AN ORDINANCE TO REZONE APPROXIMATELY 22.64 ACRES OF PROPERTY AT 12440 & 12582 LEBANON ROAD, MAP 053, PARCELS 101.01 AND 102.00 FROM CG AND CRC TO CMU PUD AND TO ADOPT THE PRELIMINARY MASTER DEVELOPMENT PLAN FOR ELLIOTT RESERVE

ELLIOTT RESERVE
PMDP & LAND USE AMENDMENT
12440 & 12582 Lebanon Road
Mt. Juliet, Wilson County, Tennessee
Map 53 - Parcels 101.01 & 102.00

GRADING &
DRAINAGE PLAN

C2.00

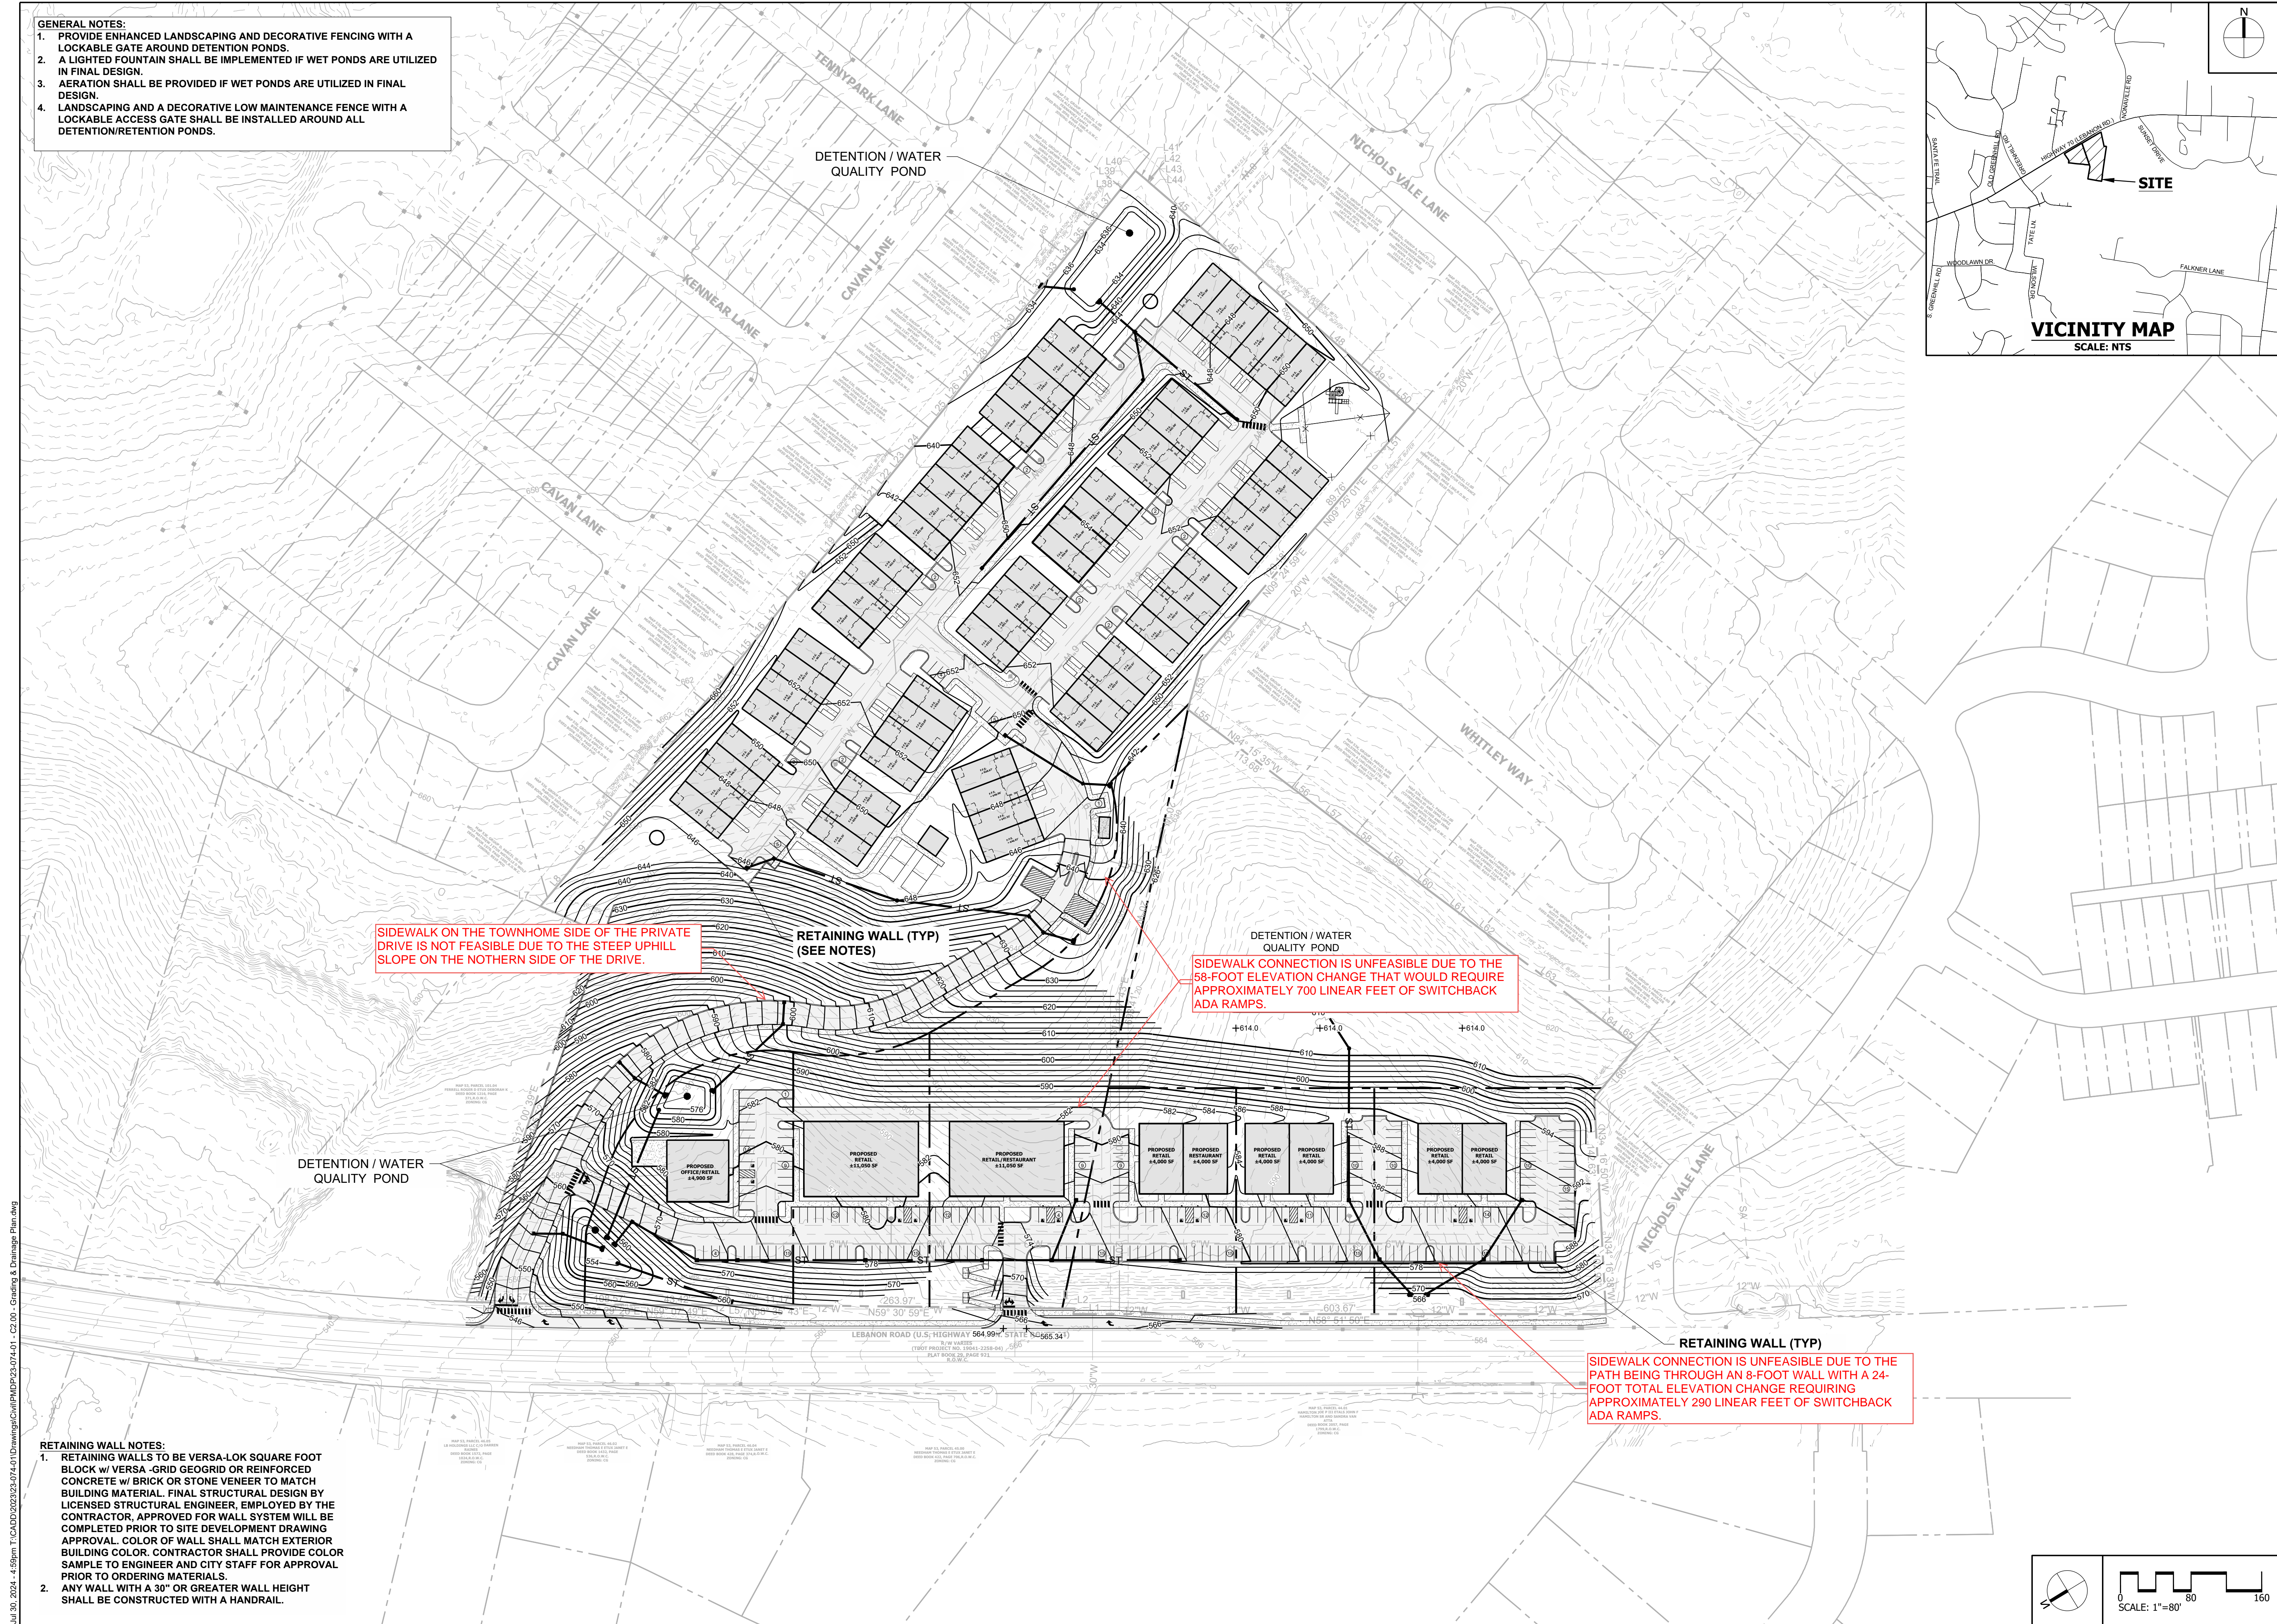
3. Place the parking behind the commercial structures along Lebanon Road and move the structures to the front setback.
4. Provide a sidewalk on both sides of the access drive to the townhomes.

7. Provide a pedestrian connection between commercial lots 4 and 5 from the drive aisle to the townhomes.
8. Identify the percentage of the PUD devoted to commercial uses in the site data table.

25. Provide sidewalk connection from the ROW to the commercial area at the Western end of Lot 7.
26. Provide a pedestrian connection from the townhome access road to the commercial areas between lots 4 and 5.

Commented [JP2]: We have proposed one sidewalk on the private drive to the townhomes, but a second sidewalk will be difficult since the drive is being cut into the steep hillside. Please see exhibit attached.

Commented [JP3]: This connection is unfeasible since it would be approximately 700' of switchback ADA compliant ramps. Please see exhibit attached.

Commented [JP6]: This connection is unfeasible since it would be approximately 290' of switchback ADA compliant ramps. Please see exhibit attached.

Commented [JP7]: This connection is unfeasible since it would be approximately 700' of switchback ADA compliant ramps. Please see exhibit attached.

SIDEWALK ON THE TOWNHOME SIDE OF THE PRIVATE DRIVE IS NOT FEASIBLE DUE TO THE STEEP UPHILL SLOPE ON THE NORTHERN SIDE OF THE DRIVE.

SIDEWALK CONNECTION IS UNFEASIBLE DUE TO THE 58-FOOT ELEVATION CHANGE THAT WOULD REQUIRE APPROXIMATELY 700 LINEAR FEET OF SWITCHBACK ADA RAMPS.

SIDEWALK CONNECTION IS UNFEASIBLE DUE TO THE PATH BEING THROUGH AN 8-FOOT WALL WITH A 24-FOOT TOTAL ELEVATION CHANGE REQUIRING APPROXIMATELY 290 LINEAR FEET OF SWITCHBACK ADA RAMPS.
